Access Compliance Report

Public Rights-of-Way

(Curb Ramps)

Intersection ID: 11025	Main Street: CAMP_GREENE_ST	Cross Street: ELON_ST	Location: NW
ADA ID: 168292E5C4A3	Ramp Type: Perp	Initial Pass/Fail: Fail	Overall Compliance: No
		Severity Score: 10

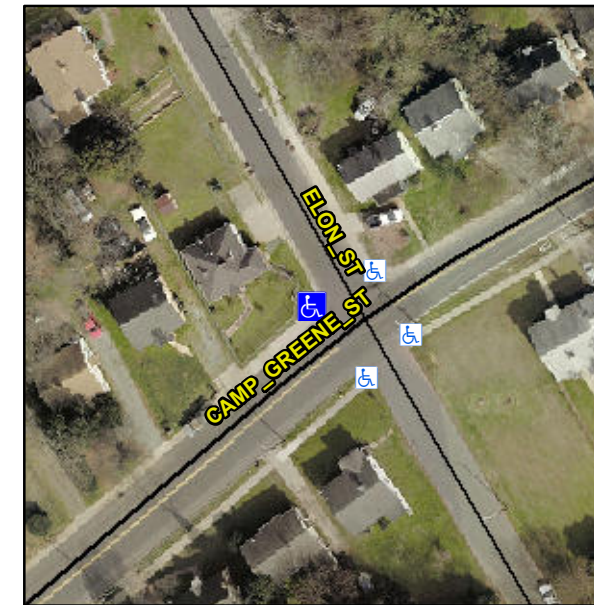
Not Found, R304.5.1, R304.5.3

Compliance	Description	Data	Compliance	Description	Data
N/A	Ramp Length (in)	72.0	Yes	Ramp Slope (%)	7.0
No	Ramp Width (in)	47.0	No	Ramp XSlope (%)	2.4
N/A	Flare Type LT	N/A	N/A	Flare Type RT	N/A
N/A	Flare Slope LT (%)	N/A	N/A	Flare Slope RT (%)	N/A
N/A	Flare Traversable LT?	N/A	N/A	Flare Traversable RT?	N/A
N/A	Landing Length (in)	N/A	N/A	DWS Provided?	N/A
N/A	Landing Width (in)	N/A	N/A	DWS Contrast?	N/A
N/A	Landing Slope (%)	N/A	N/A	DWS Length (in)	N/A
N/A	Landing X Slope (%)	N/A	N/A	DWS Full Width?	N/A
N/A	Landing Curb? (Y/N)	N/A	N/A	DWS Offset (in)	N/A
N/A	Shared Landing?	N/A			
N/A	Gutter Ponding?	N/A	N/A	Gutter Slope (%)	N/A
N/A	Gutter Lip Ht (in)	N/A	N/A	Gutter X Slope (%)	N/A
N/A	Painted X Walk1?	No	N/A	Painted X Walk2?	N/A
	X Walk 1 Direction	To E		X Walk 2 Direction	N/A
N/A	X Walk 1 Width (in)	N/A	N/A	X Walk 2 Width (in)	N/A
	X Walk 1 Slope (%)	7.0		X Walk 2 Slope (%)	N/A
	X Walk 1 X Slope (%)	1.2		X Walk 2 X Slope (%)	N/A

Remove & Replace Entire Ramp.
